Stakeholder Comments Template

Variable Operations and Maintenance Cost Review

Submitted by	Organization	Date Submitted
Mark Smith Chris Karbuch	Calpine	1/21/20

The following chart appears to be a representative basis of the CAISO's proposal to establish reference and scaled default costs.

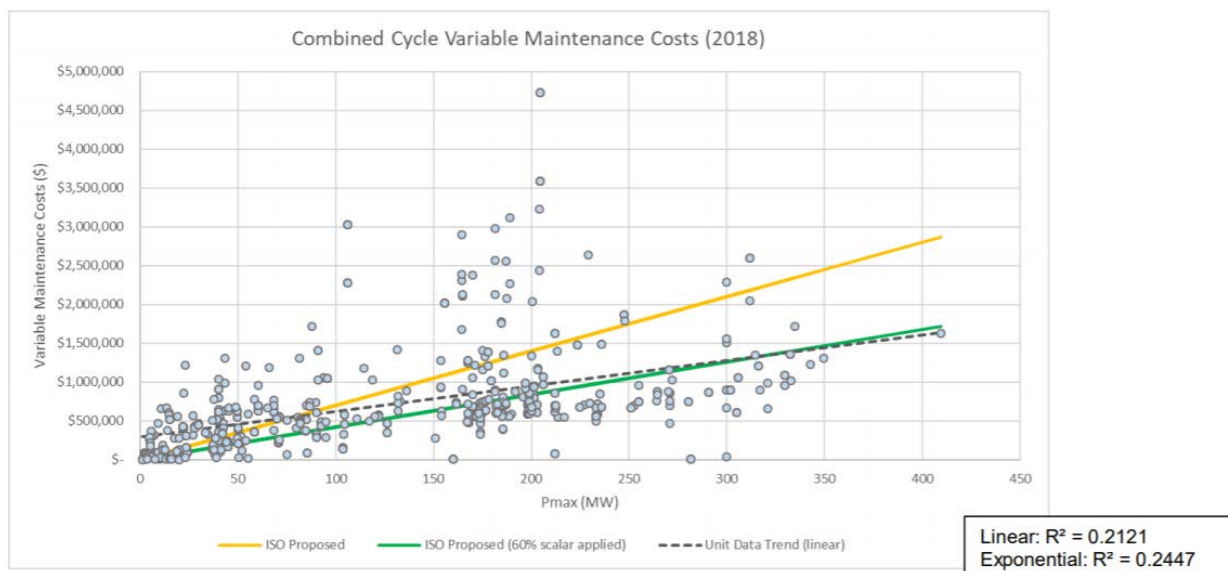
Representative data, does not appear to be representative

The data included in this table does not seem to represent the scale and scope of Calpine's operating assets. In particular, our CCGTs generally range from 120 MW all the way up to 900 MW. The configurations also vary, with some units in which one combustion turbine is connected to a single steam turbine – or as many as four combustion turbines are mated to a single steam turbine. The scale of the representative units does not encompass most of our machines and the configuration-basis of the units represented are not known. Certainly these data need further explanation.

Calpine opposes linear scaling

The regression results of the scatter plot strongly suggests that a linear model does not explain the data (R^2 of .21). Our own experience with multiple CCGT configurations (4x1, 3x1, 3x2, 2x1 and 1x1) confirms that cost data is not linearly scalable in the simple format suggested. As such, we are very concerned that the linear scaling will not represent the costs of the various configurations in the family of CCGTs.

Calpine opposes the 60% scaling factor

The choice of a 60 percent scaling factor seems arbitrary. Accepting, for the moment, that the reference unit data represents average values (simplifying to say 50 percent above and below), by scaling averages down (50 percent * 60 percent) the proposal seems to be setting default values at 30 percent of the sample. This would result in a very large number of individual negotiations. In fact, our rough calculations suggest that virtually all of our units would require negotiated rates.
